CITY OF CONWAY, ARKANSAS HISTORIC DISTRICT COMMISSION

September 28, 2026 • 5:30pm • 1111 Main Street

A. 124, 130, 136 Conway Blvd (HDR-0726-0117) Multi-family development

Old Conway Design Overlay District

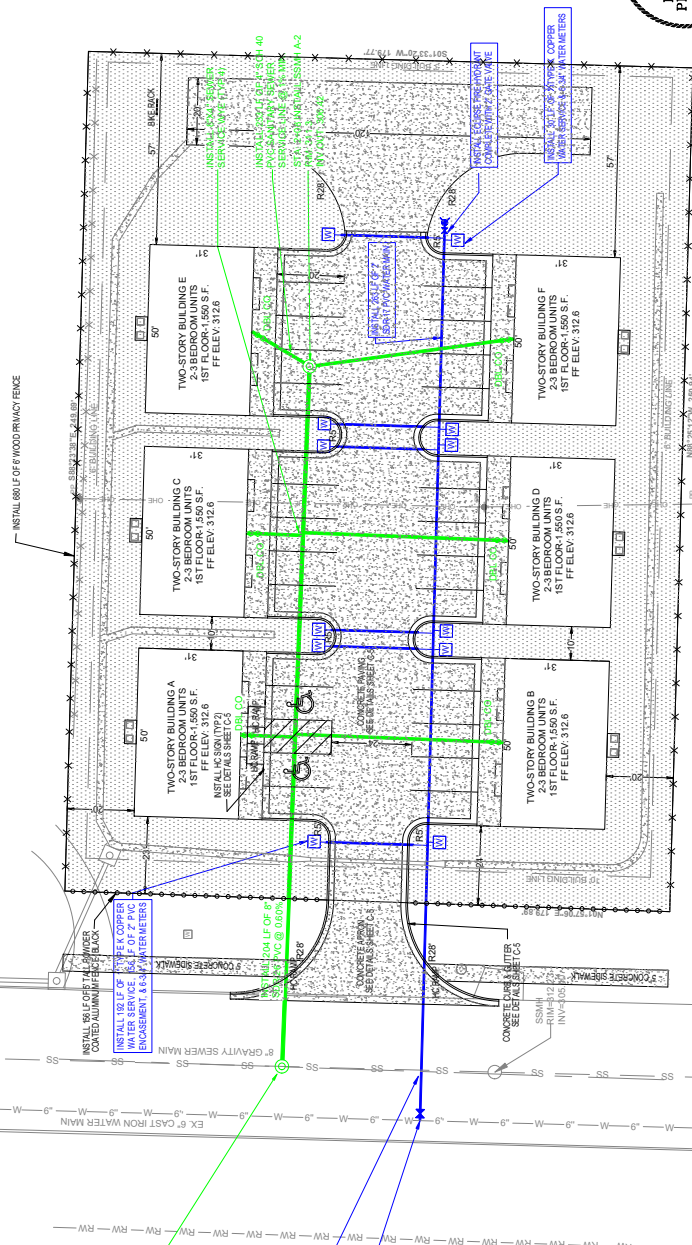
The average front setback for the area is 20', based on five homes on the same block. The applicant should have a setback within the range of 17' and 23'. The applicant is proposing a front setback of 23' and 24'.

Per the Conway Zoning Code, the applicant is required to have a 20' landscape buffer between development and adjacent residential properties. The applicant is showing the 20' setback/buffer on both side yards.

The applicant is showing a 57' rear setback.

Lot coverage for this site is ~~52%~~ 59%. The proposal conforms.

There is a shared driveway/parking area internal to the site. The proposed material is concrete. ~~30~~ 20 parking spaces are proposed. According to the Conway Zoning Code, the recommended minimum number of parking spaces for multi-family development is 18 spaces and the maximum is 48. The number of parking spaces is appropriate.

No trees are shown on the site plan. There may be some existing trees along the property lines. Existing trees which are not diseased/damaged must be retained. There is 180ft of street frontage. Six canopy trees must be planted along the Conway Blvd frontage. The applicant must also meet the criteria for landscaping in the Conway Zoning Code for Site Development Review.

- d. ~~Porches at least 6' deep~~
2. Sidewalks with greenspace shall be installed prior to issuance of a Certificate of Occupancy. The required width shall be determined by Conway Department of Transportation and shown on the plans submitted for Site Development Review (SDR).

3. Any fencing along Conway Blvd shall be iron or aluminum mimicking iron. There shall be brick columns at the north and south ends of the iron/aluminum fence. The fence shall then transition to a 6' tall wooden fence with the upper two feet composed of 50% opaque lattice which will continue along the interior property lines. An elevation showing this fence shall be provided with the SDR application and approved by Planning Staff prior to stamping SDR plans.

4. Healthy, mature trees over 8" in diameter must be retained and shown on the SDR landscaping plan.
5. Six canopy trees shall be planted along Conway Blvd. If the project enters the landscaping phase and the city is in a water curtailment period, the applicant shall coordinate with City Staff and a horticulturalist (or similar professional) to determine the best planting and management to ensure success of plantings.

Conway Blvd Duplex Project
Elevations (Building A)

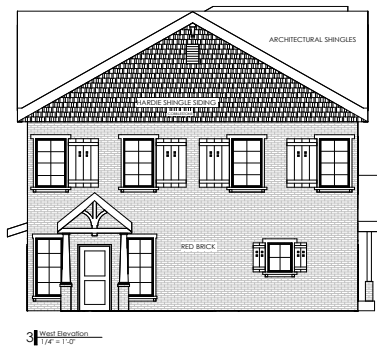
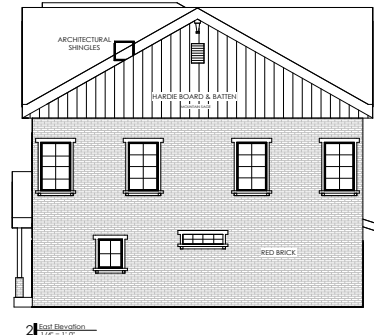
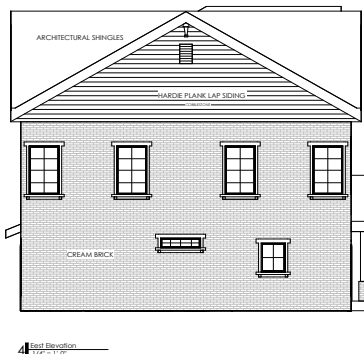
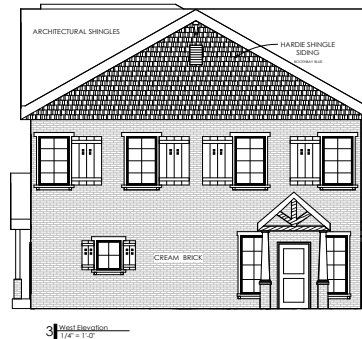
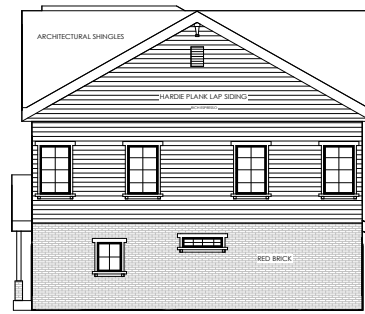
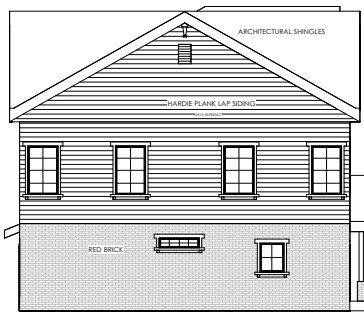
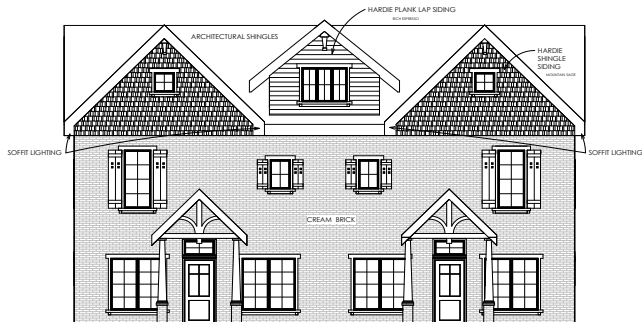
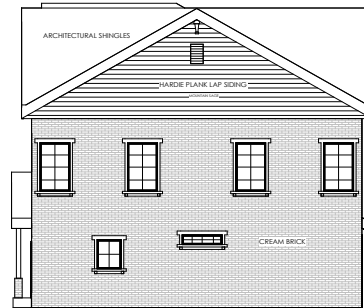
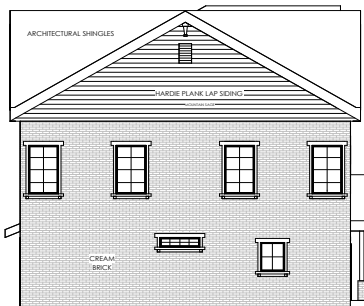
The front façades face the site internally and the Conway Blvd facing

facades are shown as the side elevations. The Conway Blvd facing elevations ~~do not~~ contain 25%-40% windows. The Conway Blvd facing elevations ~~should have been~~ adjusted to mimic front façades and ~~for~~ have architectural detailing that enhances the streetscape. ~~Additional windows should be included. At the August 24, 2026 HDC meeting, neighbors noted privacy concerns due to the height of the structures. As a result, the façades facing adjacent properties to the north and south have been modified with false windows articulated by non-operable shutters in substitution of glazed windows. This prevents a blank façade while protecting the privacy of residents in adjacent single-story, single-family residences.~~

The front porches are only 2' deep and do not conform. However, for a multi-family development, their size and style is appropriate. Entries contain decorative elements.

Shutters are proposed and they ~~must be~~ are sized so that they could fit over the windows if operable. The applicant is proposing a gable

roof and the roofing material type is ~~not specified~~ architectural shingles.

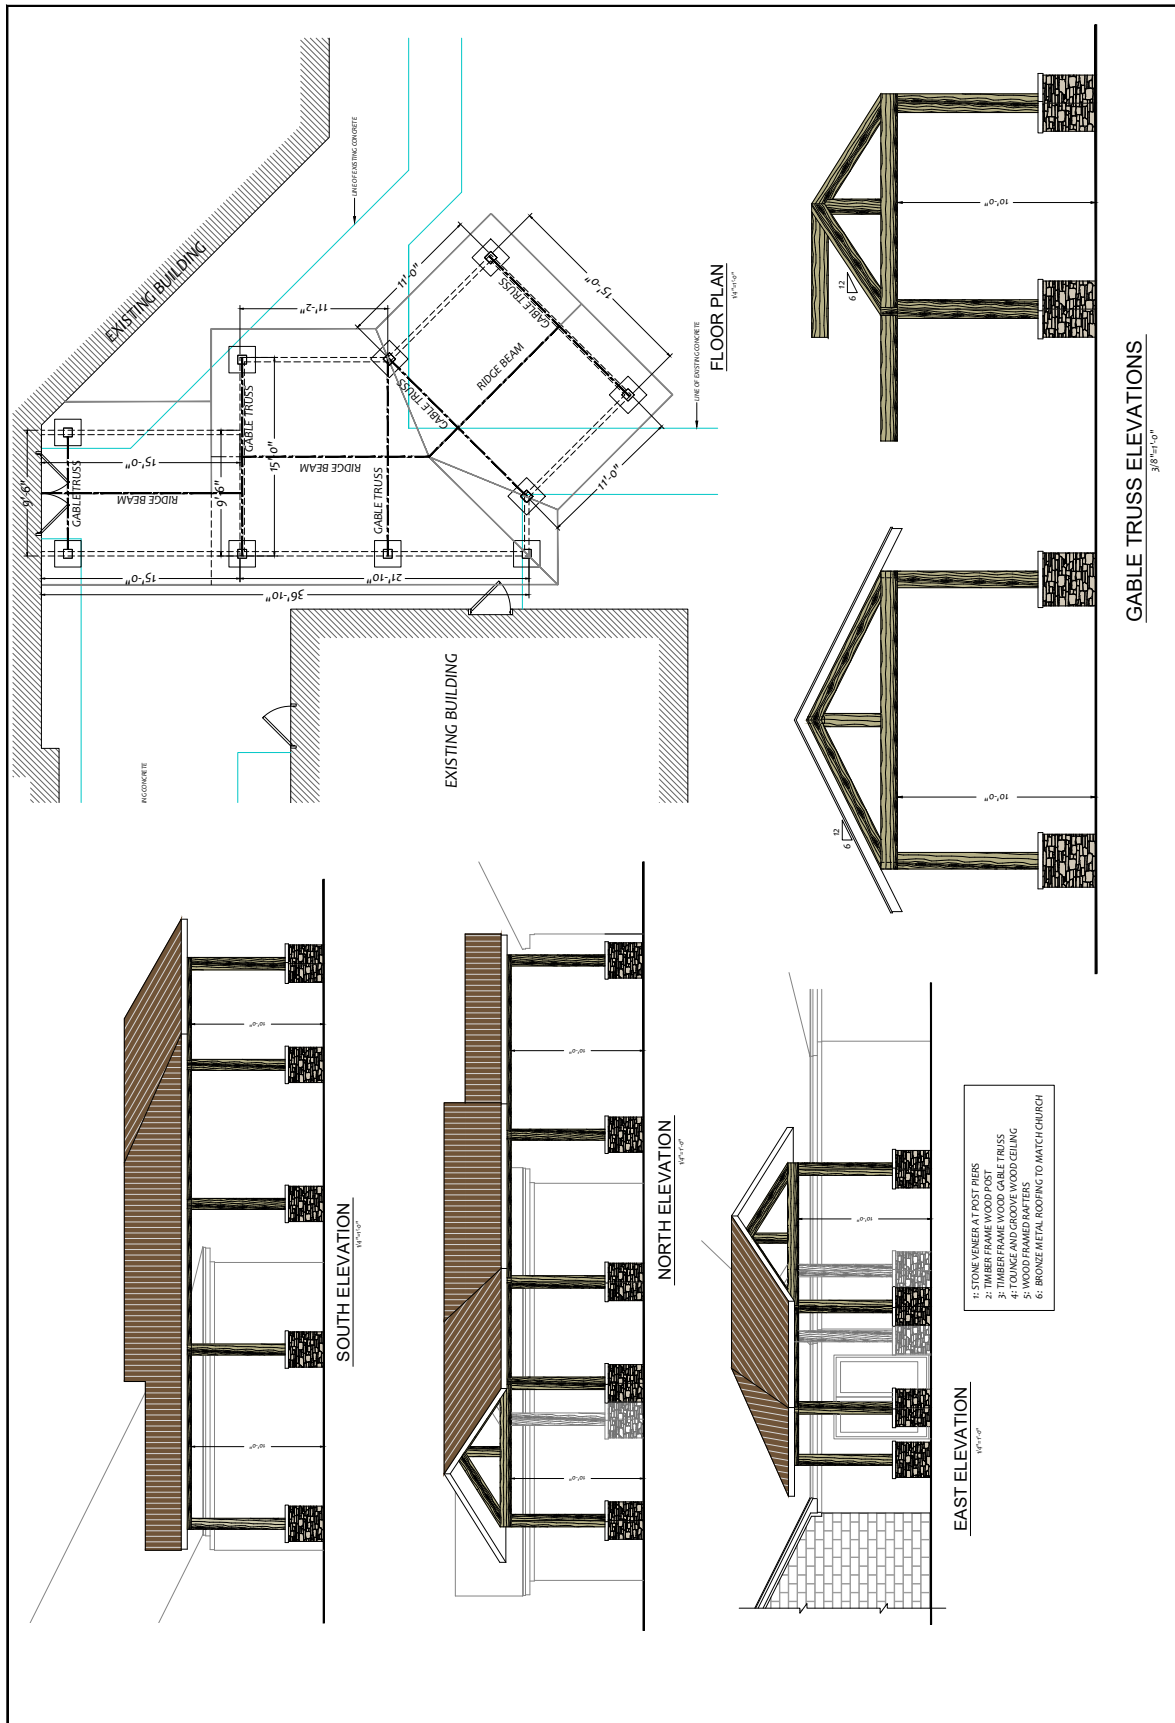
The size and scale of the addition will not overpower the existing building. The height from grade to tie beam is 10'.

The addition is compatible with the existing building in terms of location, height, scale, and materials. The proposed roofing material is metal which matches the roofing material of the existing structure.

The canopy addition could be easily removed and will have its own roof line.

SITE LAYOUT
1"=20'

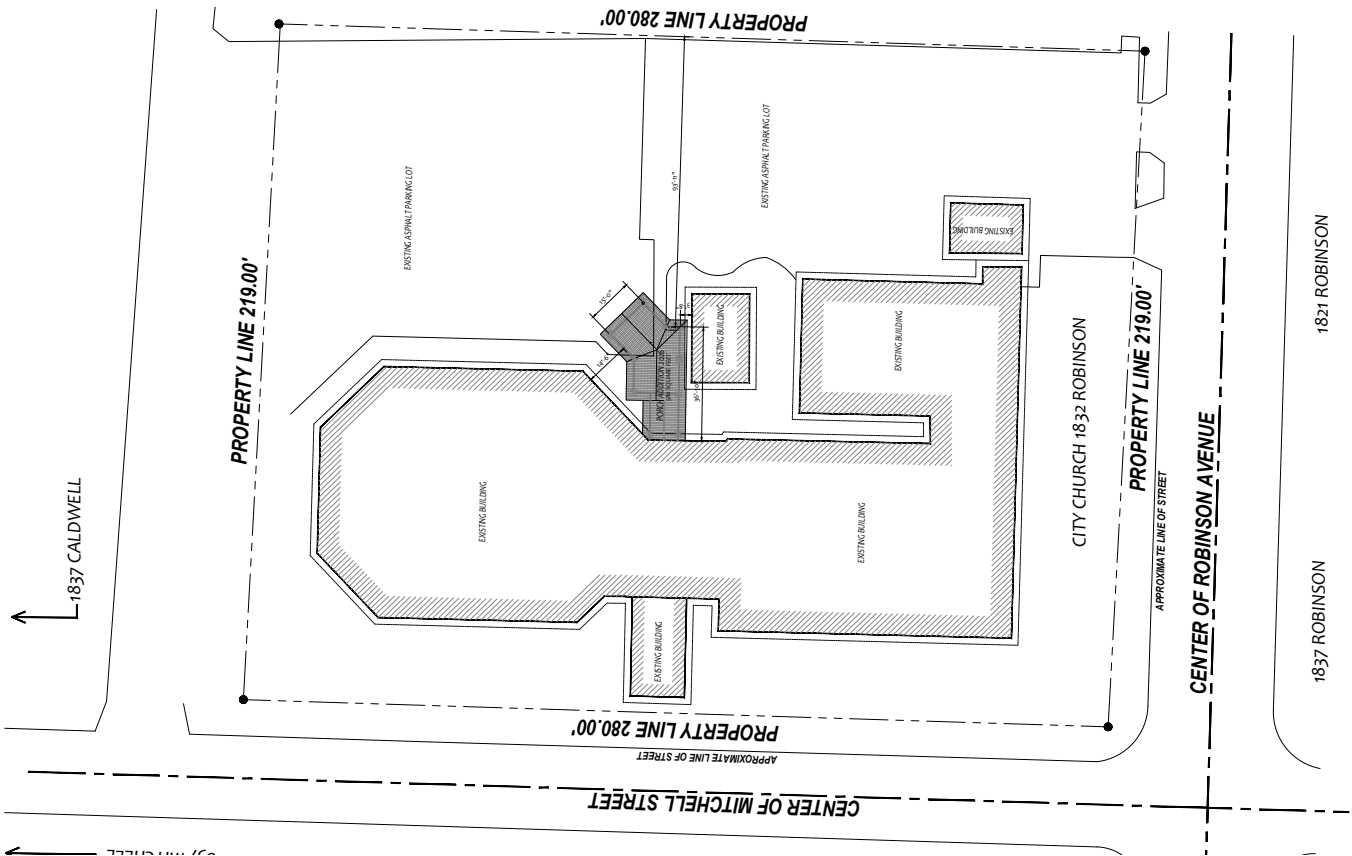
The addition is along the eastern side of the existing structure and must conform to side yard setbacks. It is proposed at 93' from the eastern property line and conforms. There is an existing outbuilding <4' from the proposed canopy. Because the canopy is open on three sides and therefore the 10' separation between a primary and accessory structure does not apply.

The addition is internal to the site and is mostly obscured by the existing structure. It will be partially visible from Robinson Avenue. It is not visible from the public realm. It is being constructed within an already impacted, impervious area where there is parking and a concrete walkway. It will not impact the character of the site, site topography, character-defining site features, trees, and significant district vistas or views.

The addition is at the side of the structure and is inconspicuous.

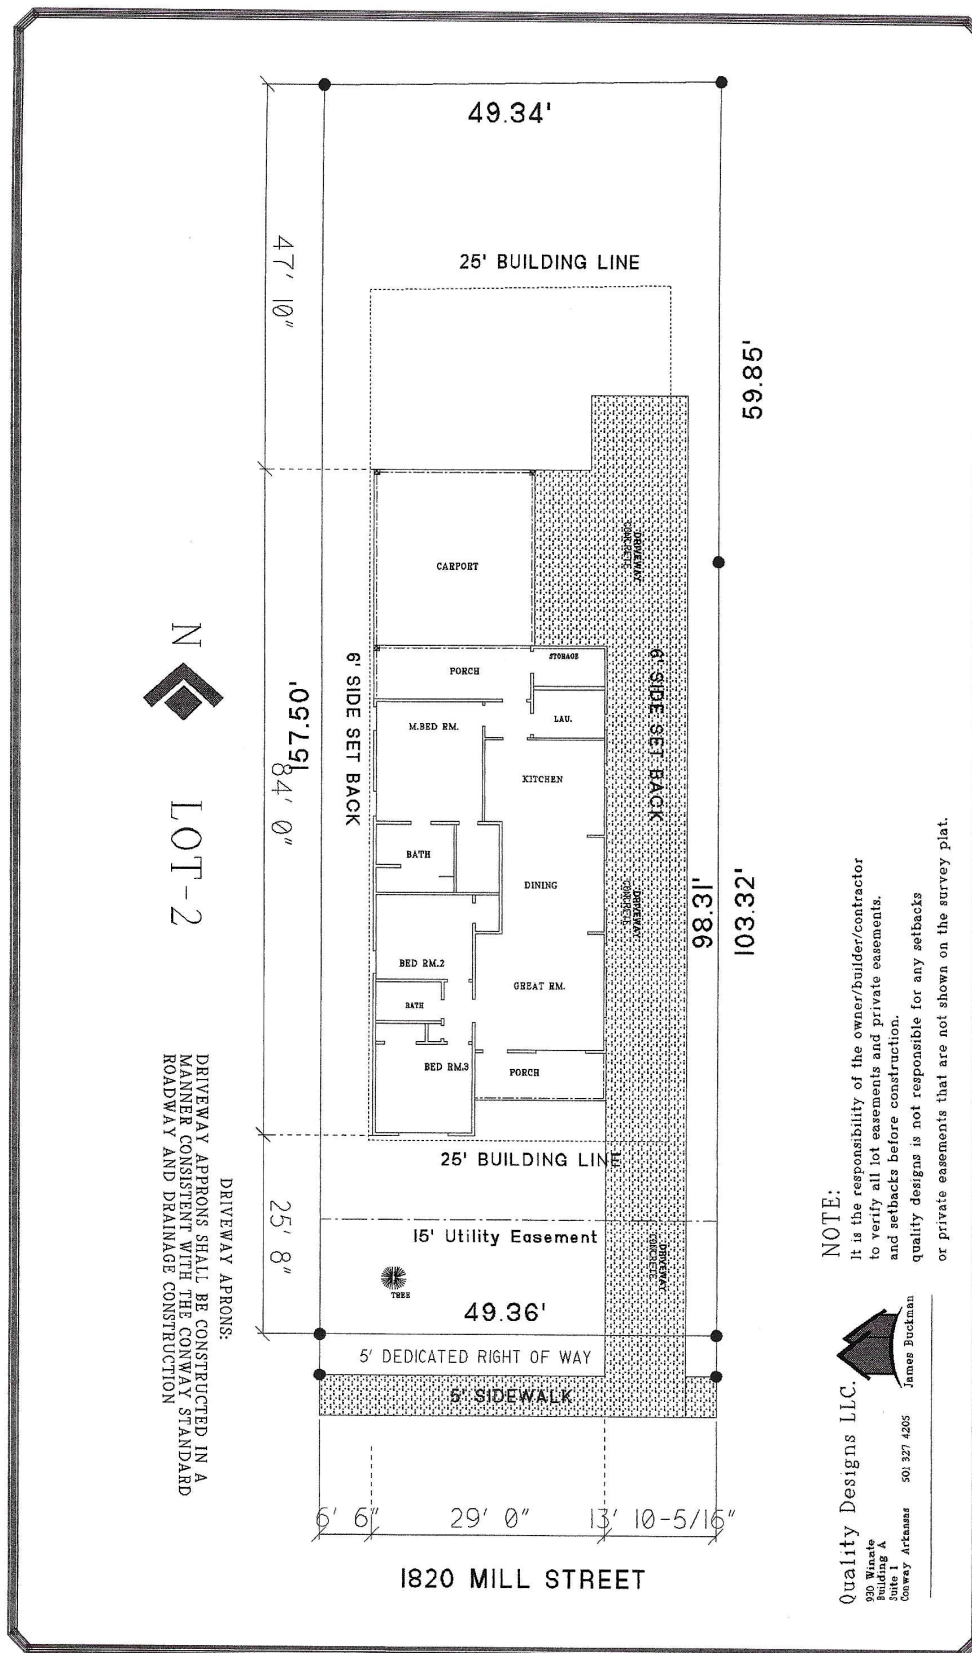
The average front setback for the area is 30', based on five homes on the same block. The applicant must set back the residence between 25' and 35' from the front property line. The applicant is proposing a front setback of 25'8". The proposed structure is 6'6" from the western side property line and 13'10-5/16" from the eastern side property line. The rear setback is 47'10". The proposal conforms.

The applicant has indicated a driveway off Mill St. near the eastern property line. A concrete driveway is proposed. It is 9' wide at the street and widens to 11' at its termination.

A 5' sidewalk and 5' of greenspace is proposed. The sidewalk appears to be proposed at back of curb while the greenspace abuts the property line. The configuration must be switched with the greenspace between the sidewalk and the back of curb.

It appears that two trees are vulnerable to removal because of construction. On tree is proposed for planting along the street frontage.

1. Applicant must obtain all applicable building permits if/when a Certificate of Appropriateness is granted.
2. Prior to issuance of a Certificate of Appropriateness, the applicant shall provide a site plan showing:

- a. Significant trees to be removed and to be retained
3. Fencing shall be no more than 6 feet tall and is only allowed in rear yards or side yards as deemed appropriate. Privacy fences shall be setback from the front façade at least one-half the distance between the front and rear walls of the structure with it transitioning down to 3.5 feet tall as it transitions to the front and/or side yard. Fences may be constructed of wood or a wood-like material.

4. One tree shall be planted. If beneath the power line it shall be an understory tree and if away from the power line it shall be a canopy tree. Any significant trees removed must be replaced at a 1:1 ratio.

5. Driveway shall be concrete, pavers, or permeable paving and shall not exceed 15' in width.
6. A 5' sidewalk with greenspace between the back of curb and the sidewalk. Greenspace should be 6.5' in width but a lesser amount may be considered if right-of-way and street configuration cannot accommodate this width. In no instance shall a sidewalk less than 5' be permissible.

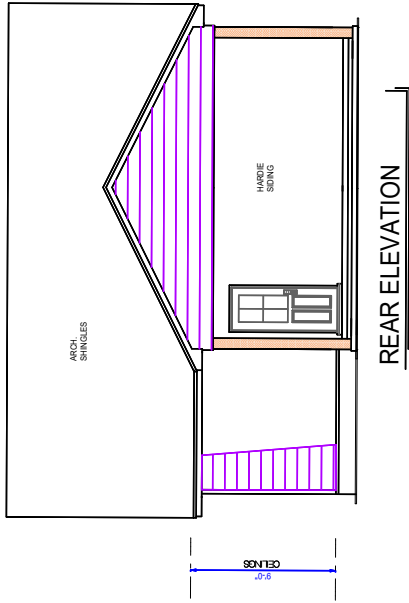
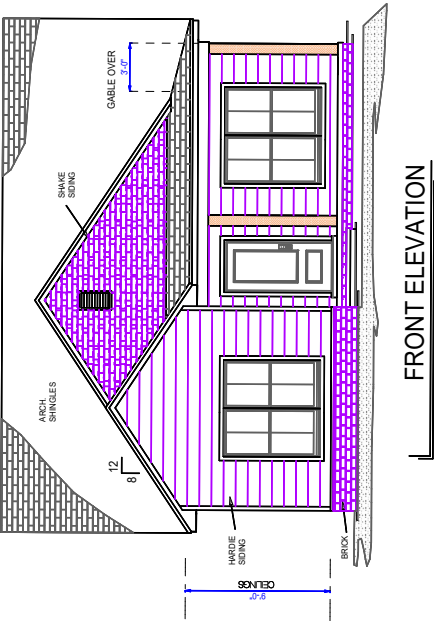
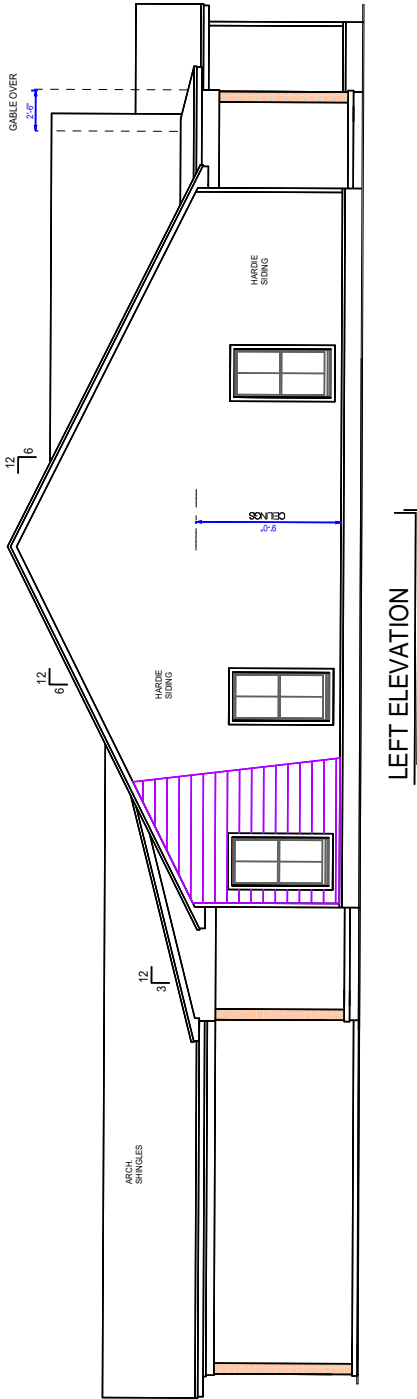
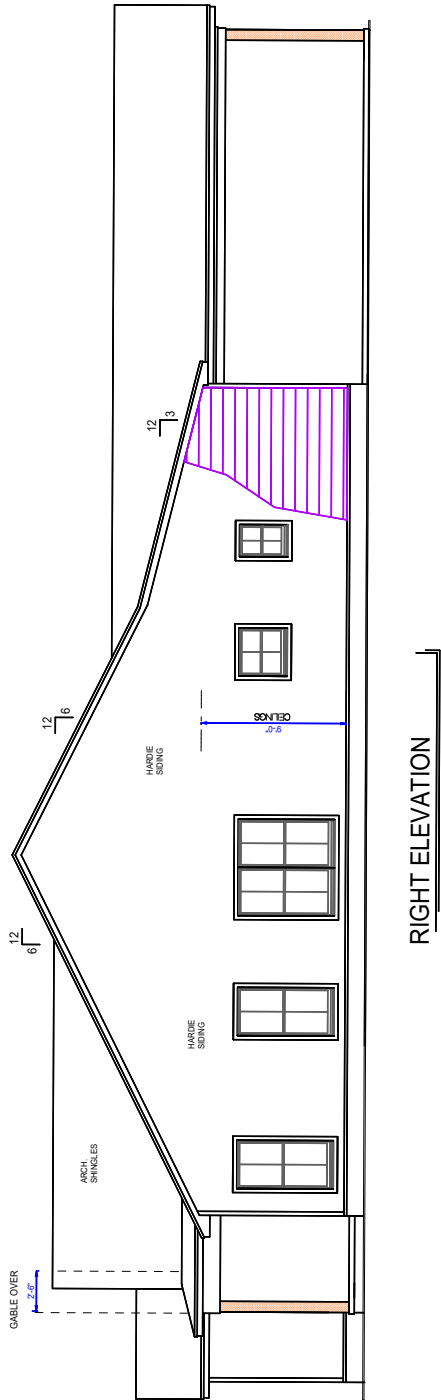
Including the front door, the front façade contains approximately 25% windows and conforms. The right elevation which will be partially visible from the public realm is approximately 20-25% and the left elevation is approximately 10% windows.

A front porch with a 6' depth is proposed and meets the requirements. Windows should have wide trim. The style of the home is not ornate and does not warrant special decorative elements at the entry.

Lighting is proposed on porches and the front elevation.

The applicant is proposing Hardie siding with brick accents as well as shake siding on the front façade eave.

The applicant is proposing a gable roof with architectural shingles. This is compatible with surrounding homes.

7. Lighting shall be downward and inward toward the property.
8. HVAC equipment shall be screened from public view.
